Subject: **PHASE SHIFT AT SDI INPUT**

Model: **BKM-101C, BVM-1454D**

Serial No: **2,000,001–2,000,872 (BKM-101C)**
2,000,001–2,000,350 (BVM-1454D)

Figure 1

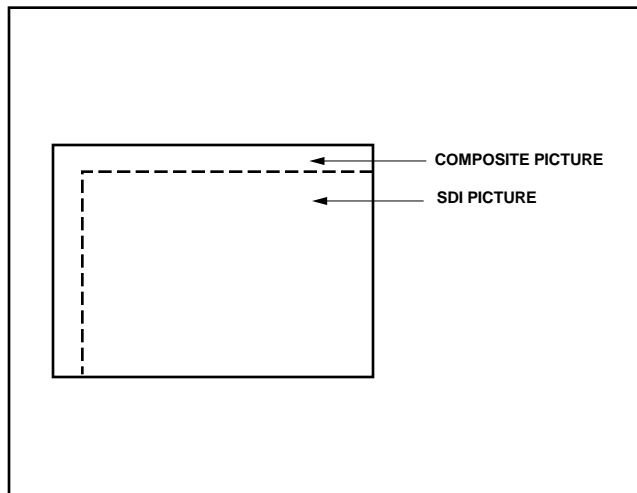
Picture framing may change between component and SDI signals due to timing differences present in the SDI signal format. Typically, the SDI picture will move lower and to the right in relation to the component picture. (See Figure 1.)

Figure 2

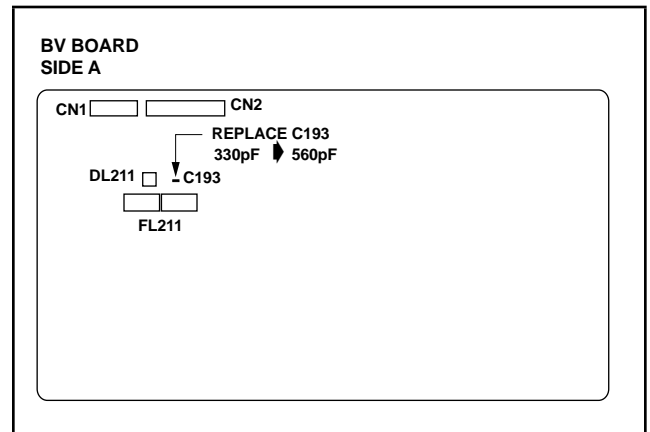
1. Replace C193 on the BV board (side A, zone G-3) with a 560pF chip capacitor as shown in Figure 2.
2. Solder a 0.047μF film capacitor (C313) on the BB board (side B) between CN11-9 and CN11-11 (see Figure 3).
3. Apply RTV glue to fix capacitor as shown.
